Omaha Public Power District
1623 Harney Omaha, Nebraska 68102
402/536-4000

August 31, 1983
LIC-83-220

Violations of 10 CFR 50, Appendix R,
Fire Protection Program for Nuclear
Power Facilities (Inspection Report 83-12)

Omaha Public Power District
Response to Notices of Violation,
Inspection Report 83-12

FIGURE 1: FIRE AREA 34B - UPPER ELECTRICAL PENETRATION ROOM
(FROM DWG. 11405-A-6)

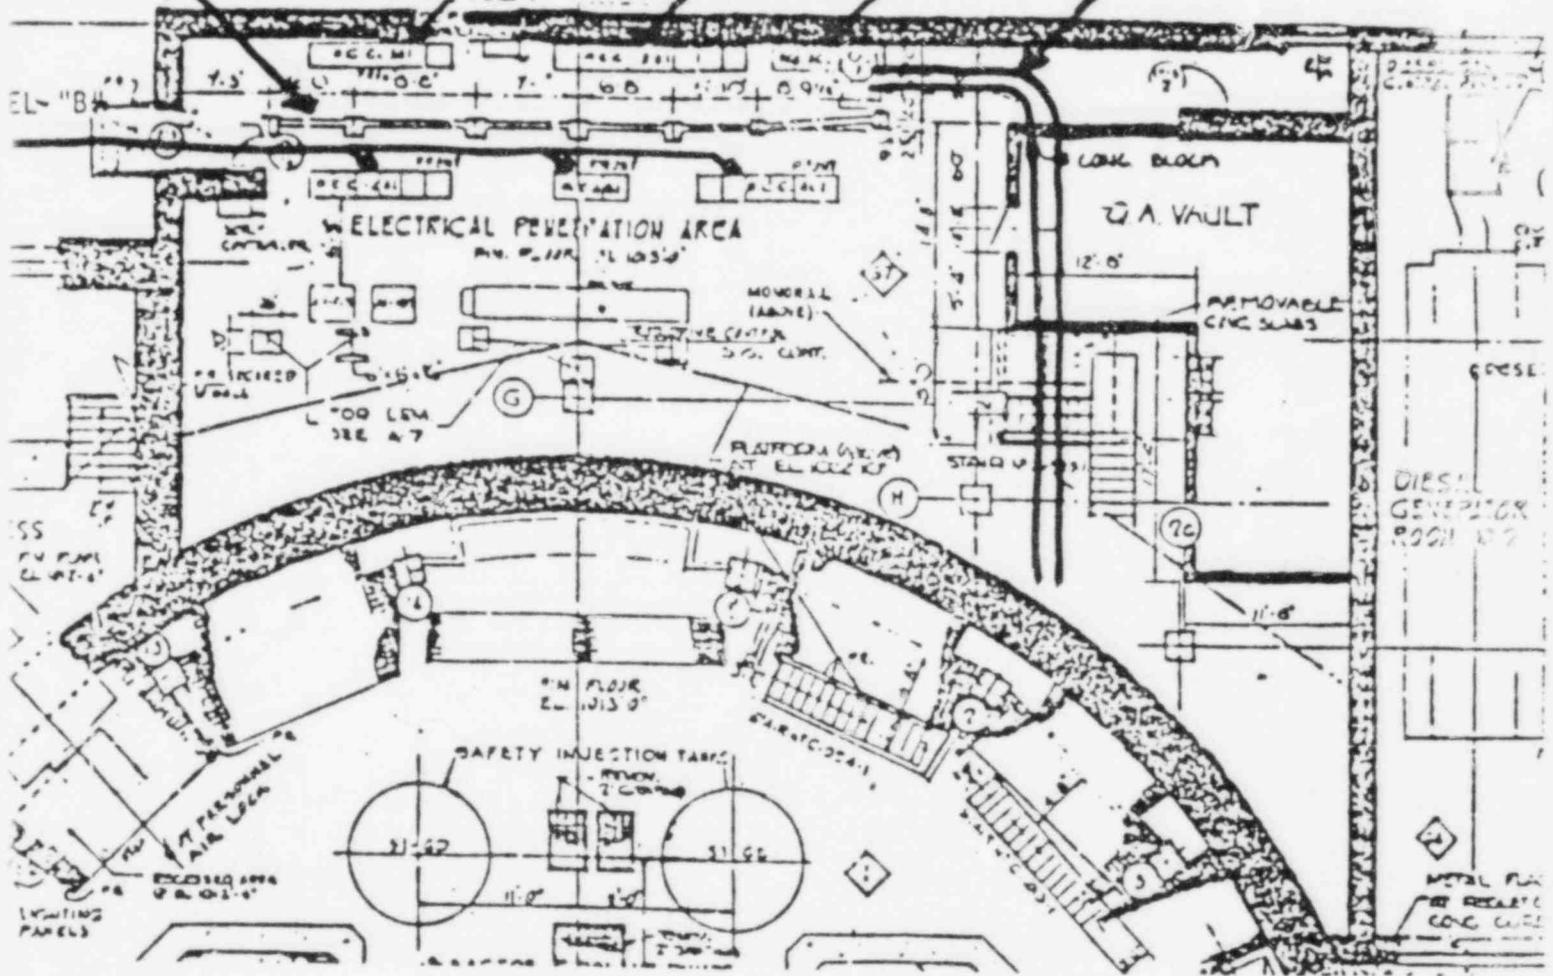
- e. Fire areas 34A and 34B (electrical penetration rooms) contain pressurizer backup heater cables - lack of separation, protection, and suppression.

II. Fire Area 34B:

(1) The cables of concern in this area are A387-A390, A404, A415, A431-A436, which are power cables for bank 1 and 2 backup pressurizer heaters. Motor Control Centers MCC-4B1 and MCC-4C1 for backup pressurizer heater banks 3 and 4 are also located in this fire area. However, all cables associated with the "B" train enter the MCC's through the bottom, therefore, for all practical purposes, no "B" cables for pressurizer heaters are in this area.

(2) The QA records storage vault is being upgraded with complete 2-hour rated walls and barriers, thus eliminating all paper in the area from area 34B combustible mass. Also, this vault has been provided with an automatic Halon fire suppression system. Maximum fire severity, therefore, has been considerably reduced.

(3) A minimum separation of 16'-0" horizontal and 9'-0" vertical exists between the "B" MCC's and the "A" cable tray 50S, further supporting the District's position that at least one bank of backup pressurizer heaters will be available for shutdown in the event of any credible fire in this fire area. (See Fig. 1)

FIGURE 2:
FIRE AREAS 35A, 35B, 36

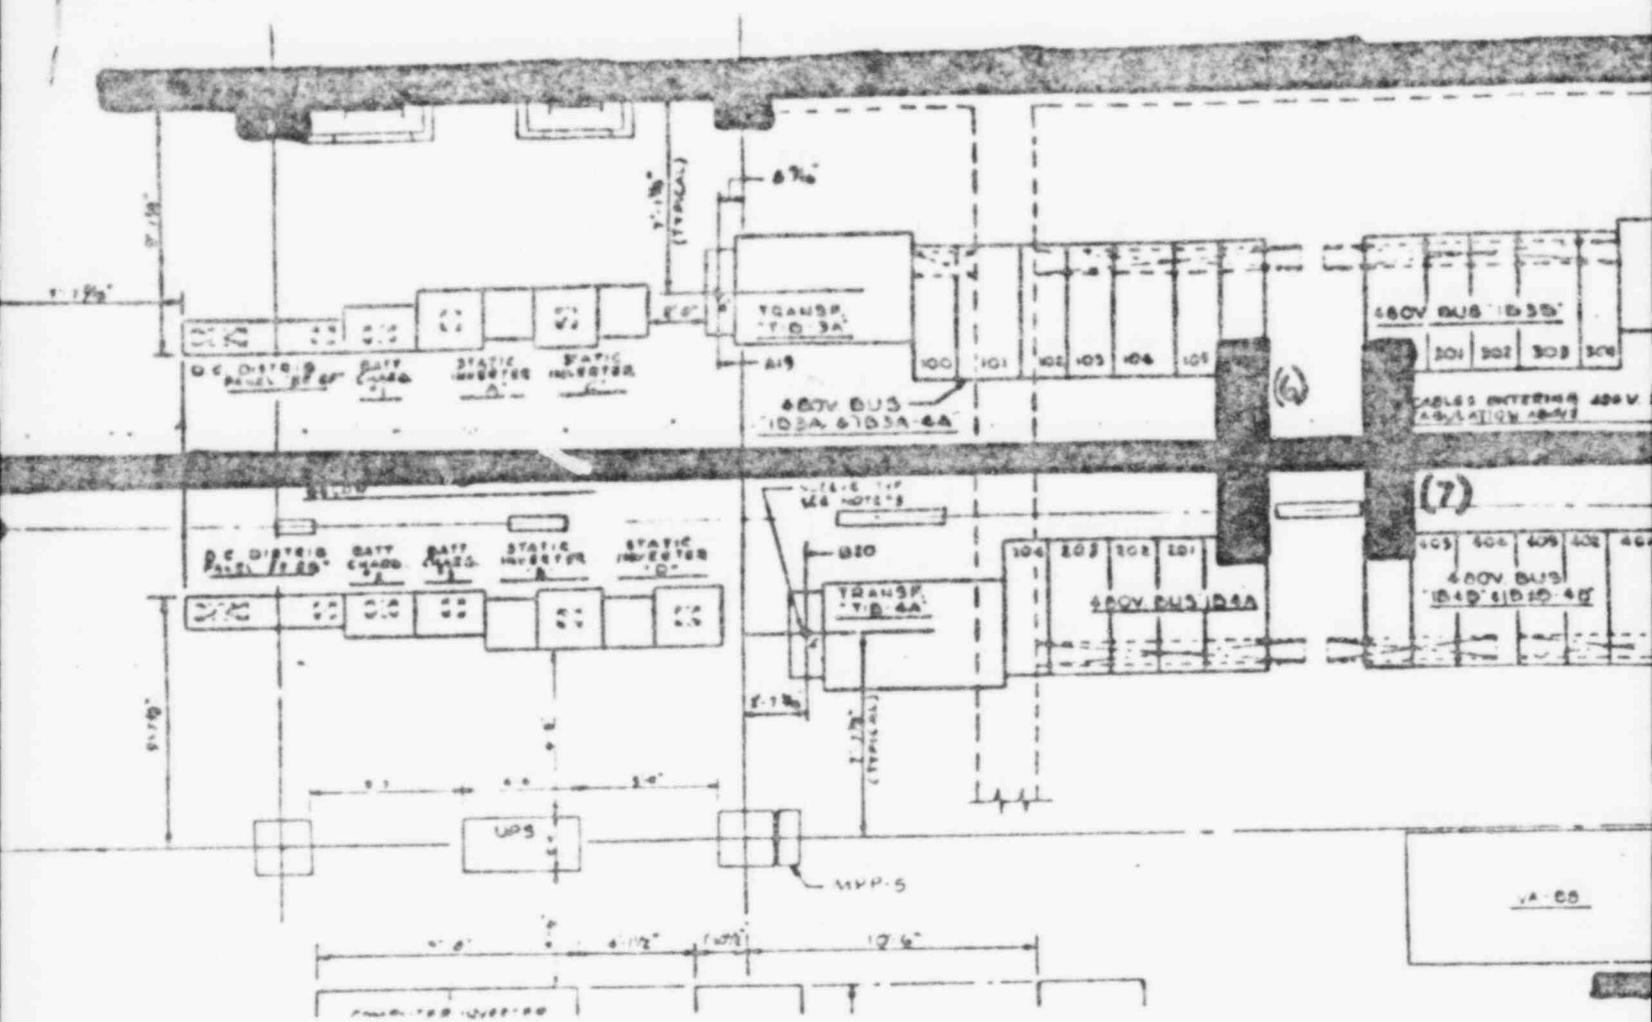
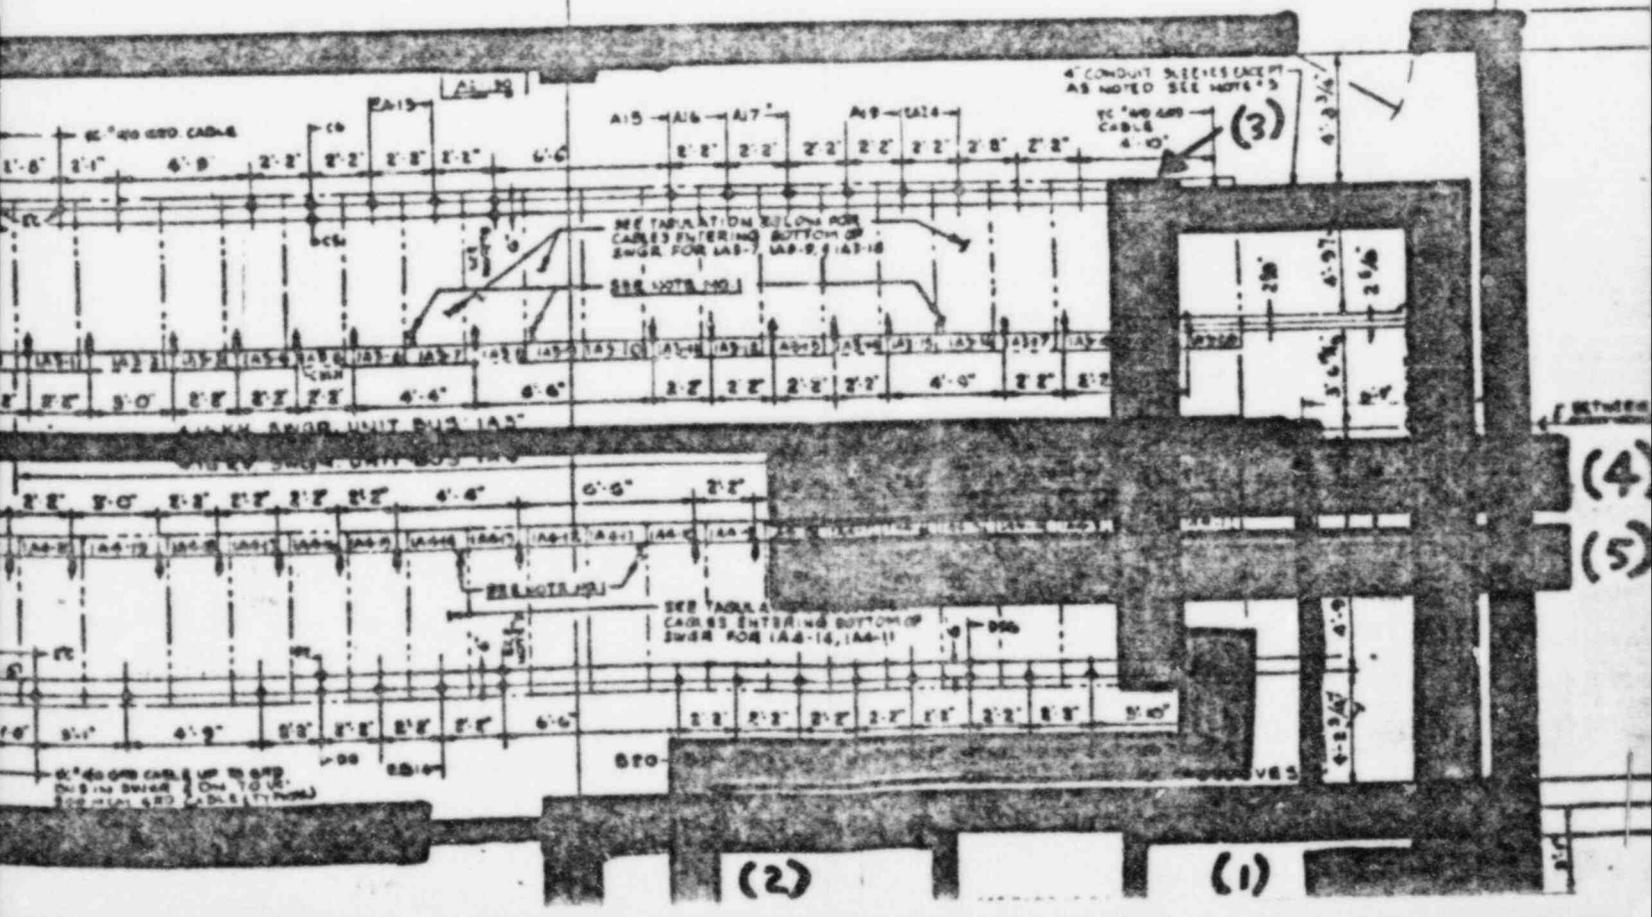
- f. Fire areas 36, 35A, and 35B (switchgear room, diesel generator rooms) have common bus work duct penetrating the fire barrier walls with no penetration seal or duct fire barrier wrapping.

The common bus ducts which penetrate fire barrier walls between the fire areas mentioned above are as follows:

- (1) 4160V bus duct connecting Diesel Generator D1 control panel (fire area 35A) with 4160V switchgear 1A3 unit 20 (fire area 36-east).
- (2) 4160V bus duct connecting Diesel Generator D2 control panel (fire area 35B) with 4160V switchgear 1A4 unit 1 (fire area 36-west).
- (3) 4160V bus duct connecting 4160V switchgear 1A3 unit 19 (fire area 36-east) with 4160V switchgear 1A4 unit 2 (fire area 36-west).
- (4) 4160V bus duct connecting 4160V "B" switchgear (fire area 36-west) with station auxiliary transformer TIA-4 (via fire area 36-east).
- (5) 4160V bus duct connecting 4160V "B" switchgear (fire area 36-west) with station auxiliary transformer TIA-2 (via fire area 36-east).

- (6) 480V bus duct connecting 480V switchgear 1B4A unit 200 (fire area 36-west) with 1B3A-4A unit 106 (fire area 36-east).
- (7) 480V bus duct connecting 480V switchgear 1B3B-4B unit 406 (fire area 36-west) with 1B3B unit 300 (fire area 36-east).
- (8) 480V bus duct connecting 480V switchgear 1B4C unit 600 (fire area 36-west) with 1B3C-4C unit 506 (fire area 36-east).

(See Figure 2)

Ducts denoted as (1) and (2) above do not require any further fire protection features because these ducts and their associated equipment are redundant and separated. That is, any postulated fire, even if it does breach a fire barrier via one of these bus ducts, will only disable one train of electrical equipment. In the event of any postulated fire in any of these fire areas, safe shutdown capability is maintained insofar as these bus ducts are concerned.

Bus ducts denoted as (3) through (8) above are provided with a UL approved silicon foam 3-hour rated fire stop material between the bus duct and the fire barrier penetrated. The silicon foam material is designed to expand up to five times its present volume in the presence of heat due to a localized fire. A fire postulated in the vicinity of the penetration made by the duct will, therefore, cause the bus duct material to melt and the silicon fire stop to expand around the bus bars, sealing off the penetration and providing the required 3-hour fire rated barrier.
